## S E R V I C E N O T E

**8665B Synthesized Signal Generator**

**I/O Assembly Replacement requires modification to Reference Assembly****Duplicate Service Notes:**

**FIGURE 1**

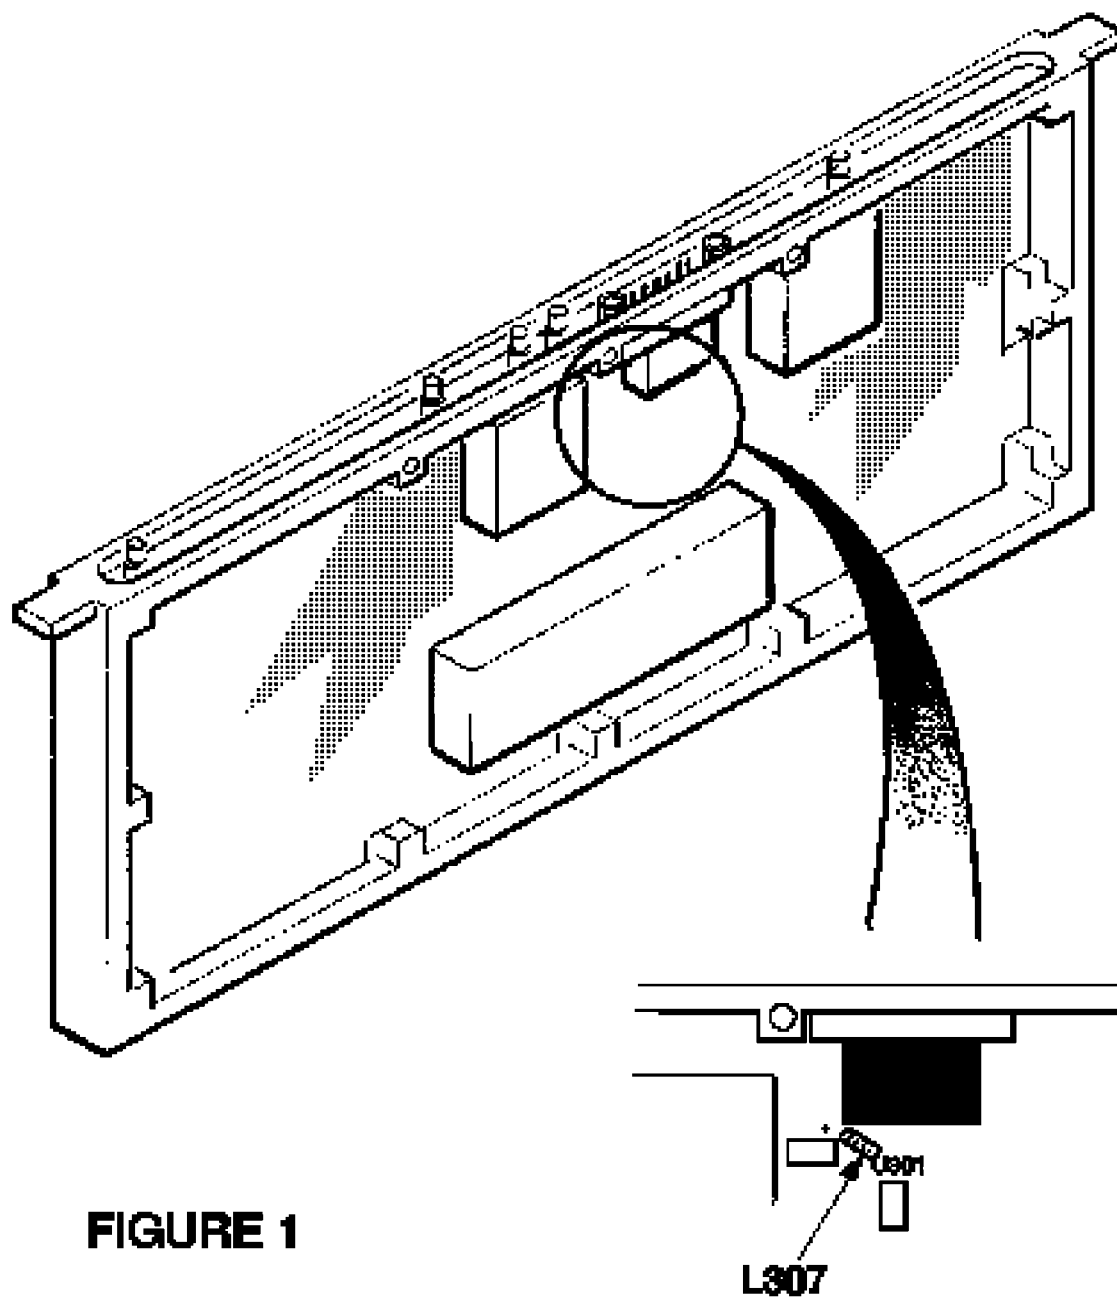
When an I/O assembly (08665-69104 or 08665-60204) is replaced in instruments (serial numbers noted above) a component on the Reference assembly (P/N 08665-61006) must be removed to insure proper operation of the reference oscillator.

Remove L307 on the Reference assembly. Refer to Figure 1 for component location. Re-calibration is not required.
